# Product/Process Change Notice (PCN)

PCN #: ConUSB\_20140626  
Product Affected: 692221030100  
Effective Date: 2014-10-15

<u>Old Design</u>	<u>New Design</u>

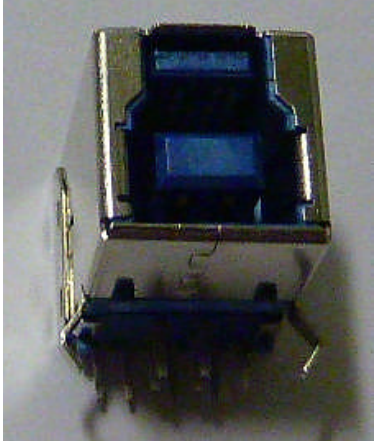
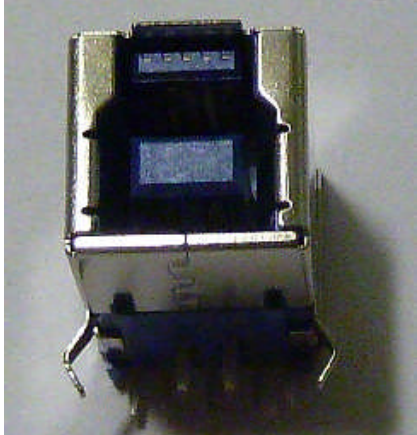
1. Color of insulator is changed to Pantone#653C to prevent it gets dark after soldering. Insulator material is the same.
2. Due to tooling change, the design of the insulator was modified to adapt to the automatic machine and to improve process control. Nevertheless, all electrical and mechanical properties and dimensions are remained the same.

<u>Old Packaging</u>			<u>New Packaging</u>		
<u>Tray dimension</u>	<u>Qty/Tray</u>	<u>Qty/Carton</u>	<u>Tray dimension</u>	<u>Qty/Tray</u>	<u>Qty/Carton</u>
345x245x17.5mm	120pcs	1440pcs	314x224x18mm	100pcs	1600pcs

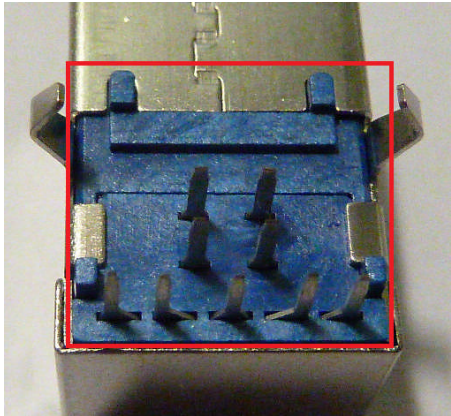
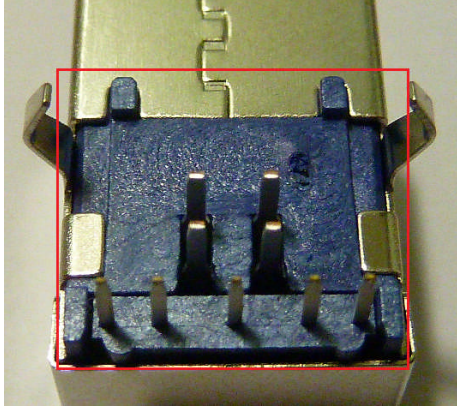
3. Dimension of tray is changed to adapt to the automatic machine. Nevertheless, tray design is kept the same.
